| Title: Improved Version For The Heat Protection On Lower Ignition Cables  |                               |   |
| AG-SB-2025-01-B-EN  | Effective Date:<br>22.10.2025 | Compliance Category:  |
| <b>Applicability</b><br><b>Aircraft type &amp; model:</b><br>AutoGyro Cavalon and Calidus with<br>ROTAX® 915/916iS engines  |                               | <b>A - MANDATORY</b><br><b>B – RECOMMENDED</b><br><b>C - OPTIONAL</b> |

Supplemental pictures:

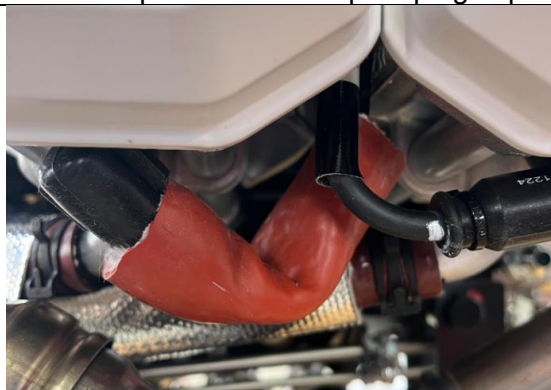
Further findings have shown that this heat shield can negatively impact the performance of the radio system. Therefore, the above-mentioned Service Bulletin was withdrawn in July 2025. With the publication of this Service Bulletin, an improved heat shield is introduced that does not negatively affect the radio system.

- 1) Remove the engine cowlings according to Chapter 52-00-00 4-1 of the respective AMM.
- 2) Remove one lower spark plug cap from the spark plug.
- 3) Cut the tie that wraps around the cap to hold it to the cable. Remove the tie
- 4) Unscrew the spark plug cap from the ignition cable.
- 5) Check if the cable is heat damaged; if so, replace. If only the end is damaged, ~5mm may be cut off.
- 6) *If present: Remove the old heat protection.*
- 7) Install the new heat shield.
- 8) Reinstall the spark plug cap onto the ignition cable.
- 9) Fit a new 2mm tie around the groove in the end of the cap and tighten. Cut off the waste.
- 10) Install the spark plug cap onto the spark plug.
- 11) Repeat steps 3) to 7) for the remaining three ignition cables.
- 12) Perform an engine test run.
- 13) Reinstall the engine cowlings according to Chapter 52-00-00 4-1 of the respective AMM.

▲ Unscrewed spark plug cap

▲ Heat protection and spark plug cap

▲ Heat protection slid onto the spark plug cap

▲ Re-Installed spark plug cap
